PG&E Letter DCL-21-040

Diablo Canyon Units 1 and 2  
Docket No. 50-275, OL-DPR-80  
Docket No. 50-323, OL-DPR-82  
Responses to NRC Requests for Additional Information on LAR 20-03, Proposed  
Technical Specifications and Revised License Conditions for the Permanently  
Defueled Condition

**Responses to NRC Request for additional information – Diablo Canyon proposed technical specifications and revised license conditions for the permanently defueled condition (EPID: L-2020-LLA-0261)**

**Figure 1**

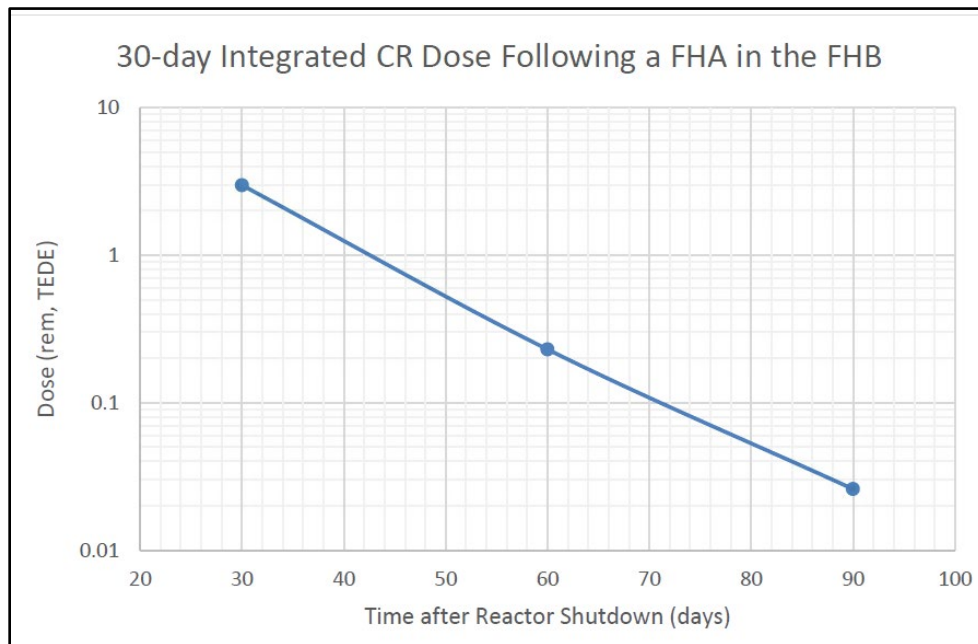
*Please provide sufficient technical details of the new FHA to allow for NRC staff evaluation. The NRC staff requests this information to include, but not necessarily limited to: key input variables, calculated dose to CR, EAB, and LPZ, source term use in the new FHA analysis, fall height of fuel assembly, water coverage, decontamination factors, and atmospheric dispersion factors.*

As demonstrated below in Figure 1, the time after permanent reactor shutdown when the CR dose is equal to the CR dose of 1.0 rem TEDE reported in the current design basis analysis of record for the FHA in the FHB is a little over 42 days. For purposes of conservatism, a minimum of “45 days after reactor shutdown” is used to stipulate when credit for operation of the CR ventilation system or FHB ventilation system is not required during fuel movement for “post-permanent cessation of power operations”, since by that time, the resultant dose in the CR would be below the current licensing basis value of 1 rem TEDE.

In summary, it was determined that a FHA assumed to occur 45 days after reactor shutdown, with conservative assumptions intended to minimize the number of systems, structures, and operating procedures credited for accident mitigation, would result in estimated doses that remain within the current licensing basis values for the FHA, specifically:
